PLANNING AND ZONING COMMISSION MEETING
Tuesday, January 24, 2017 • 7:00 p.m.
West Branch City Council Chambers, 110 N. Poplar St.
Council Quorum May Be Present

ACTION TITLE: Continued discussion of site plan for development on Hilltop Drive

SITE PLAN PEDERSEN VALLEY PART THREE - PHASE ONE, LOT 23 WEST BRANCH, IOWA

PEDERSEN VALLEY PART THREE - PHASE TWO, LOTS 41 & 42 AND PEDERSEN VALLEY PART FIVE, OUTLOT G WEST BRANCH, IOWA

SITE LAYOUT AND DIMENSION PLAN

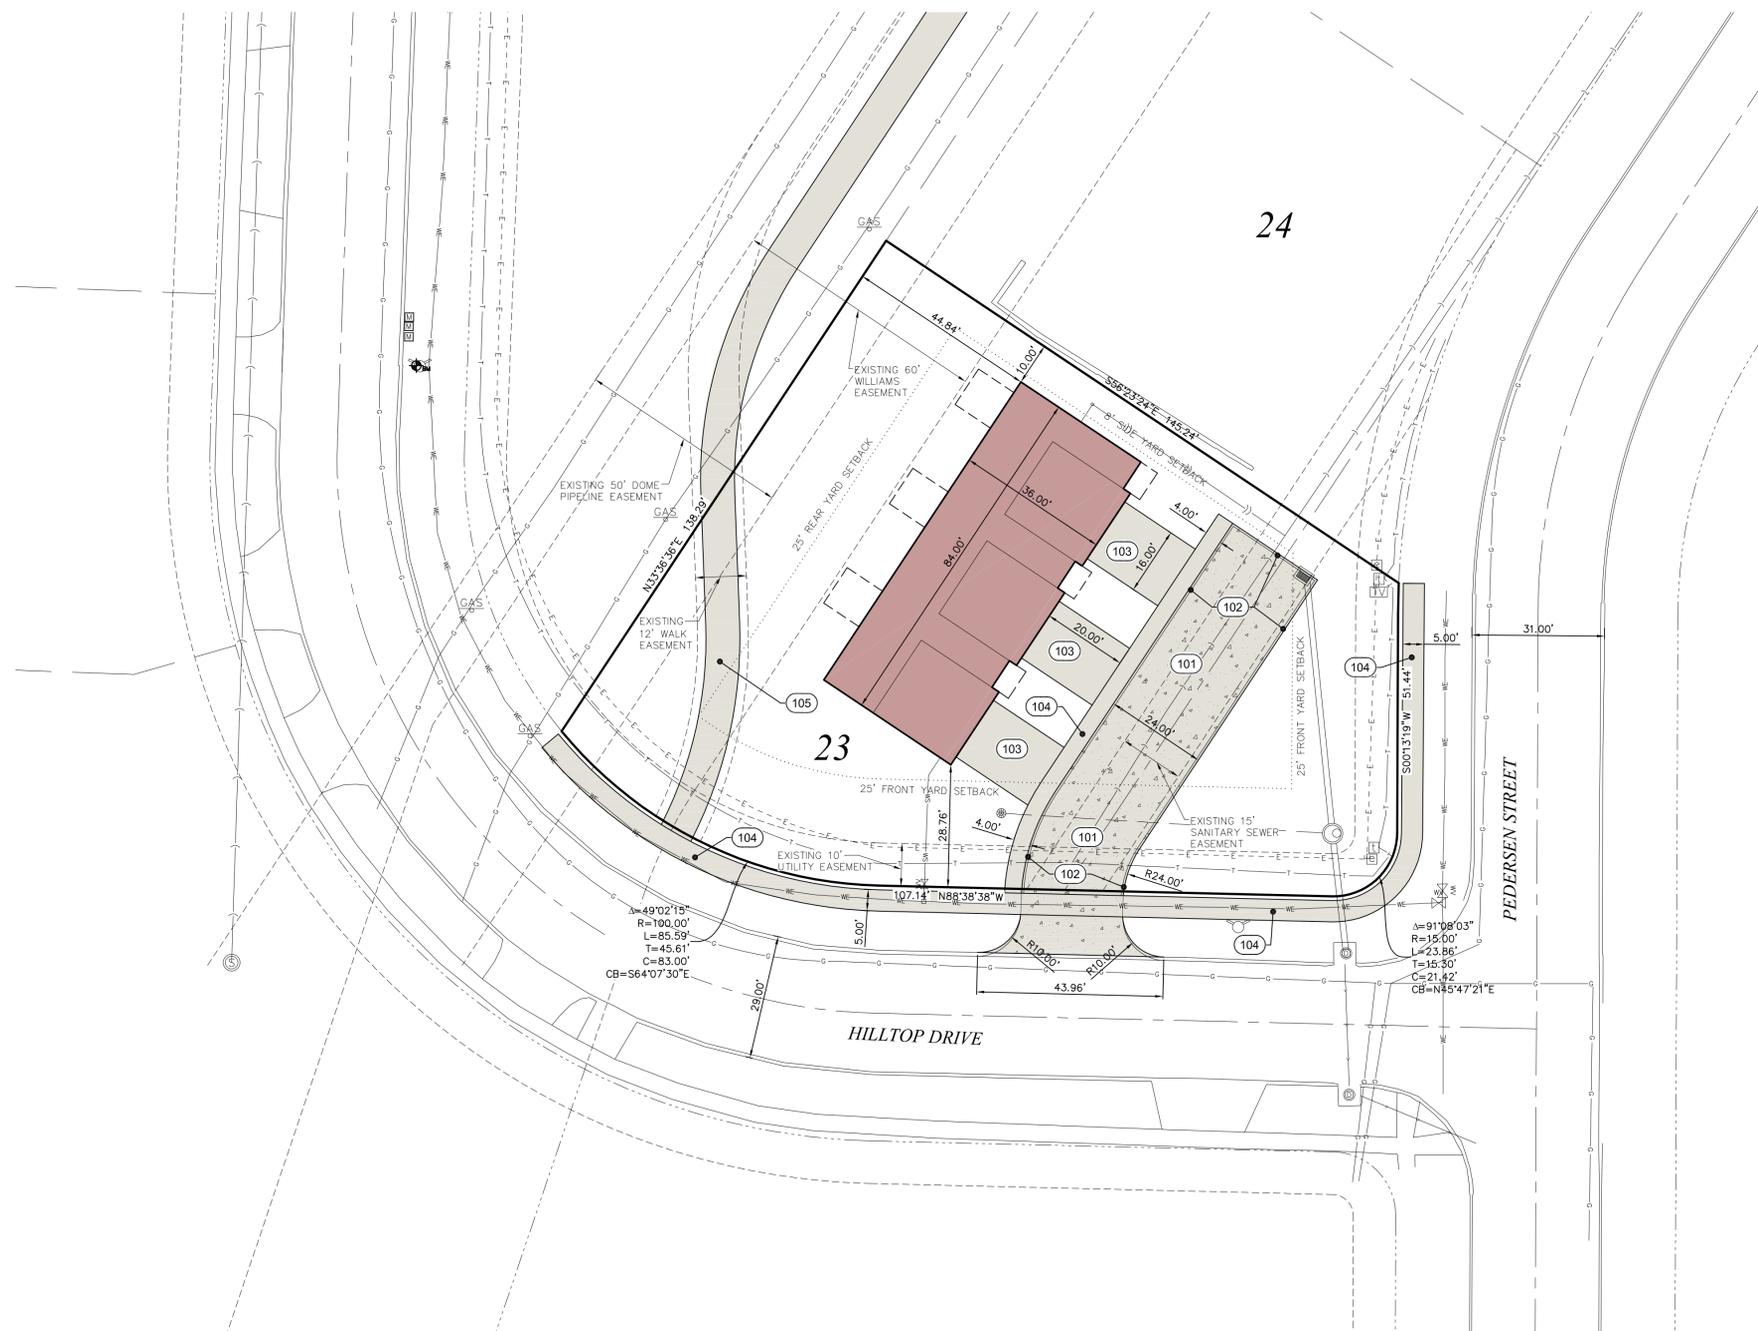
I have reviewed the site plan for Lot 23 and have provided additional comments to the check list in red. I also have the following comments:

18. Stormwater Pollution Prevention Plan. YES NO
19. Stormwater Management Plan. **Need to address increased runoff** YES NO
20. Pre-Application Conference. **Held with City** YES NO

SITE LAYOUT AND DIMENSION PLAN

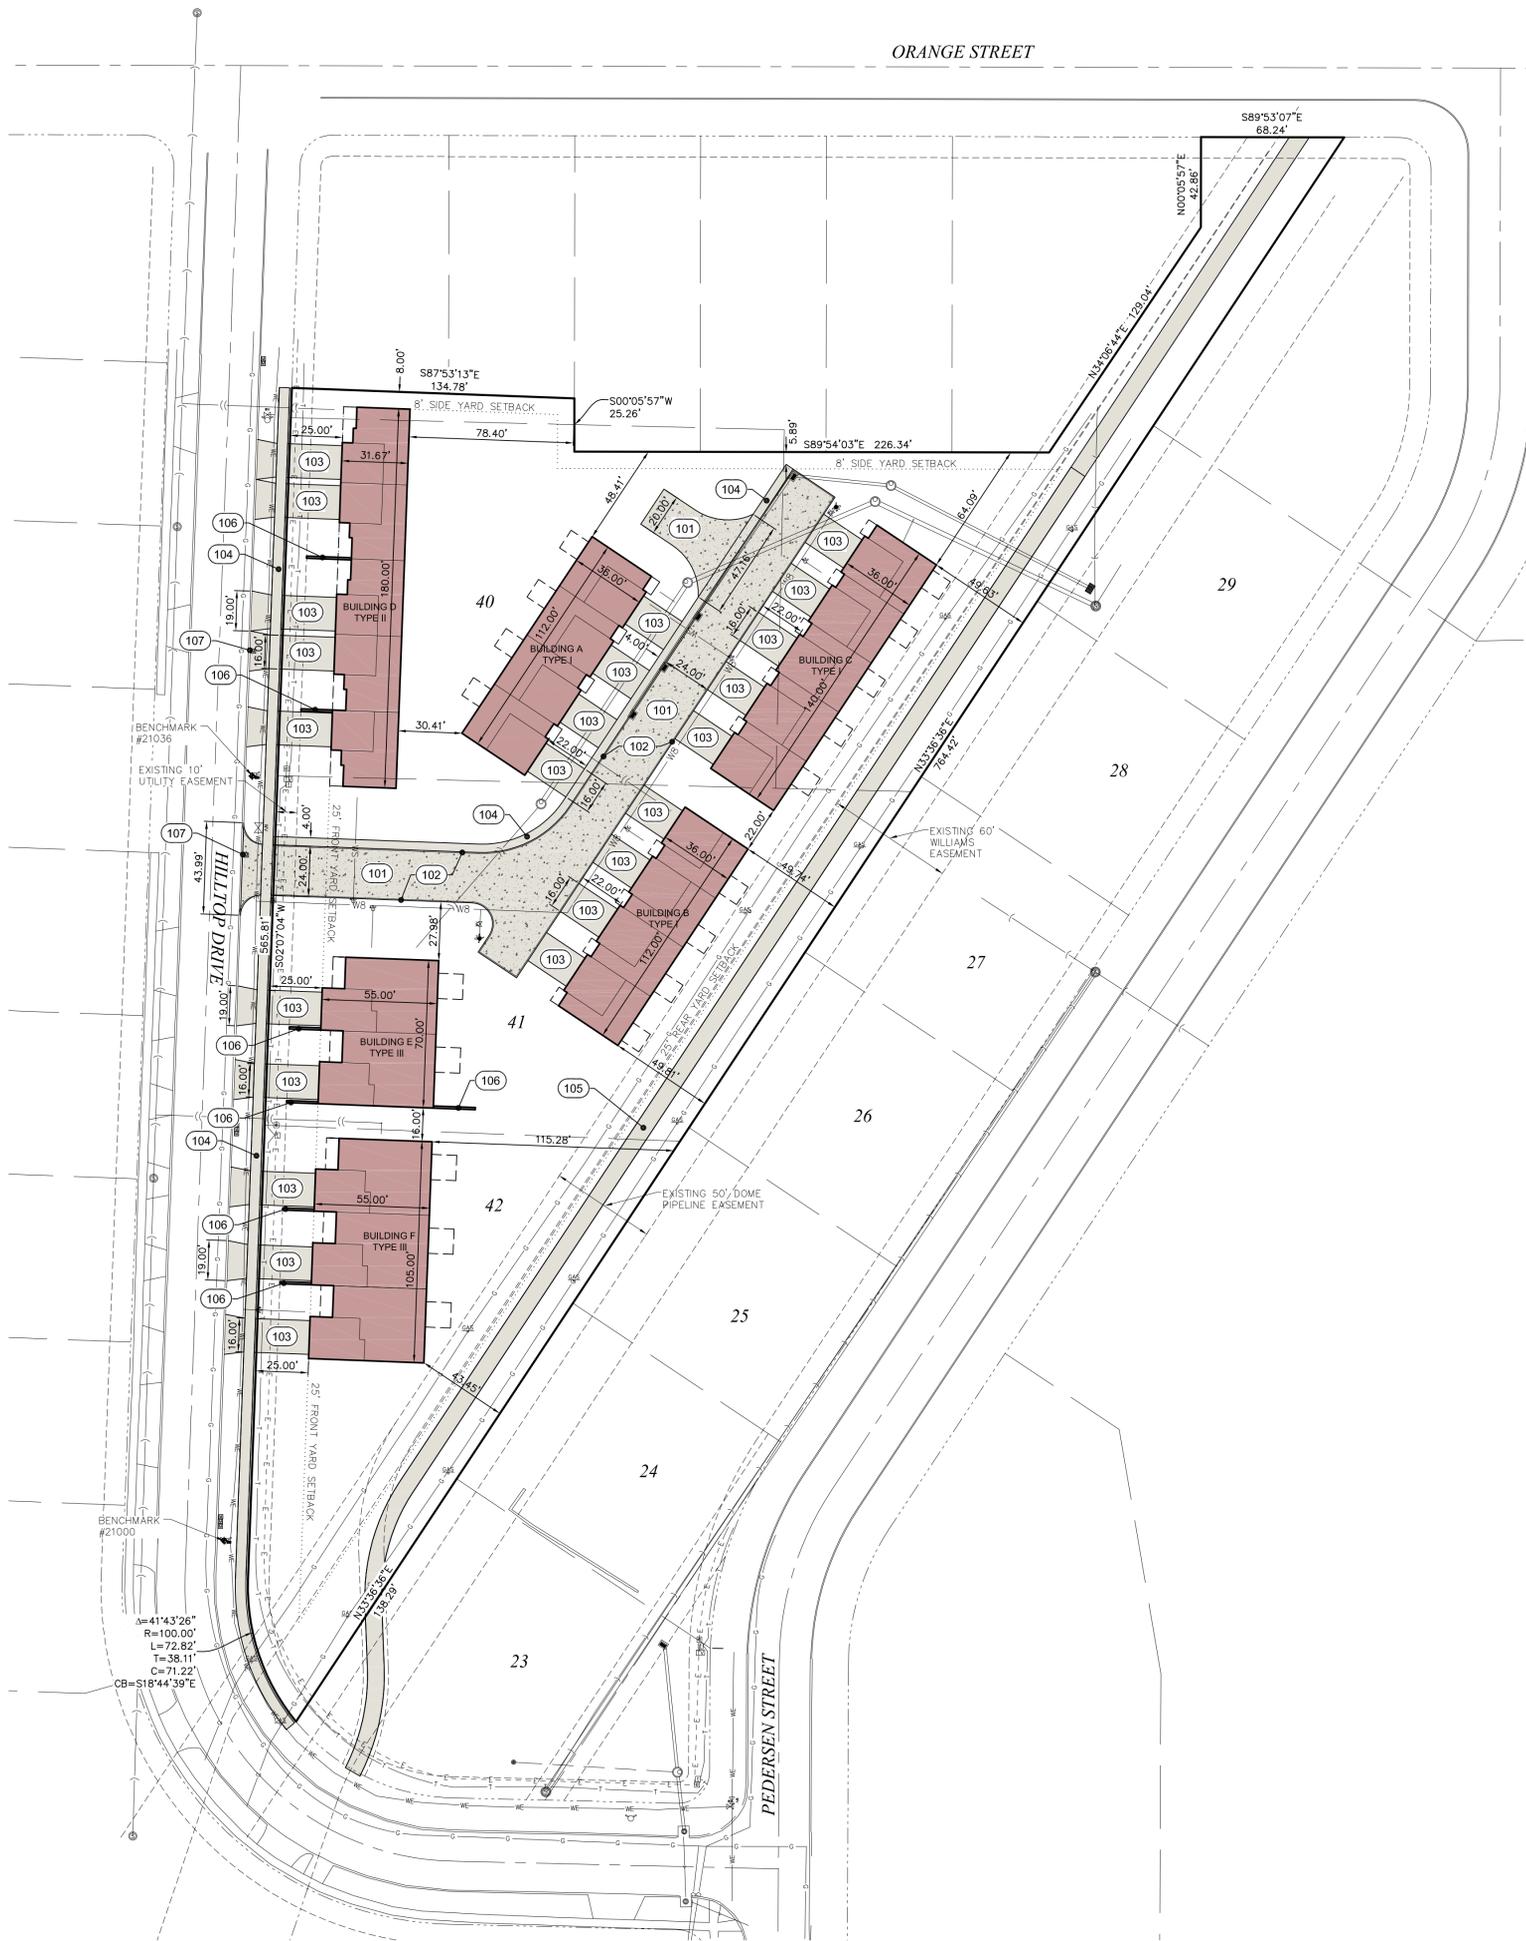
6. The (106) site walls on Sheet No. 1 need to be reviewed for height and may trigger other code requirements.
7. There was a request at the Council meeting for a traffic evaluation. Do we need to conduct a peak hour count on either end of Hilltop to address this concern?

8. Location, shape, and all exterior elevation views of all proposed buildings, for the purpose of understanding the structures and building materials to be used, the location of windows, doors, overhangs, projection height, etc. and the grade relationship to floor elevation, and the number of stories of each existing building to be retained and of each proposed building. **Provide renderings to City** YES NO

14. Location, amount and type of any proposed landscaping. Location of proposed plantings, fences, walls, or other screening as required by the zoning regulations and the design standards set forth in Section 173.03. **Dumpster?** YES NO

SITE GRADING AND EROSION CONTROL PLAN

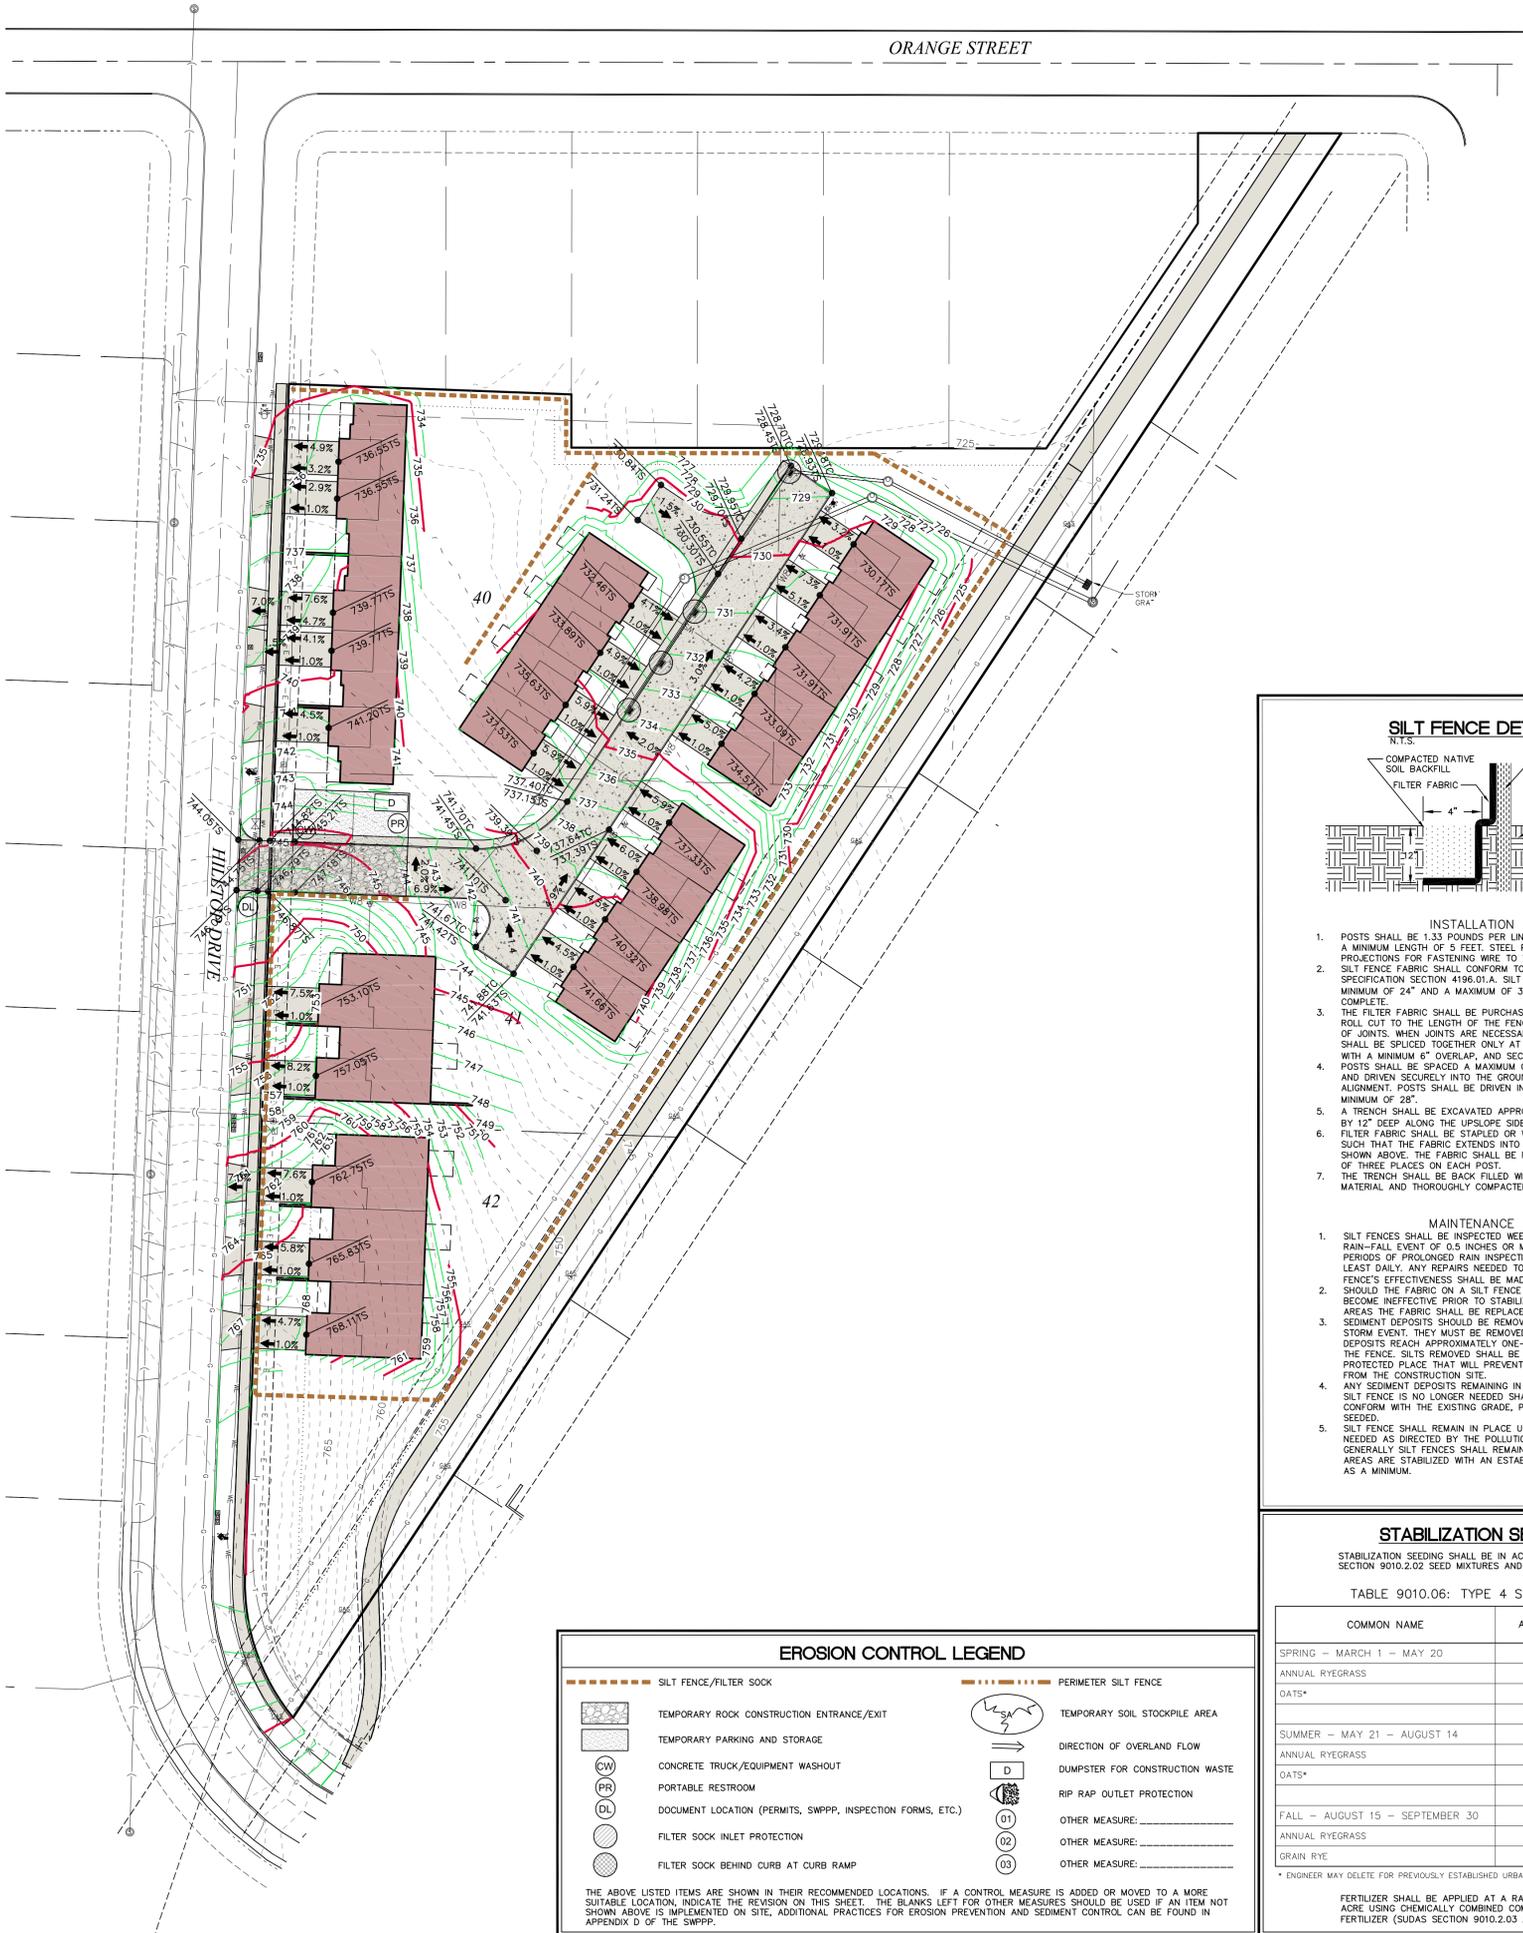
18. Stormwater Pollution Prevention Plan. **Dwg 2 Erosion Control Plan** YES NO
19. Stormwater Management Plan. **Need provisions for runoff** YES NO
20. Pre-Application Conference. **Held with City** YES NO
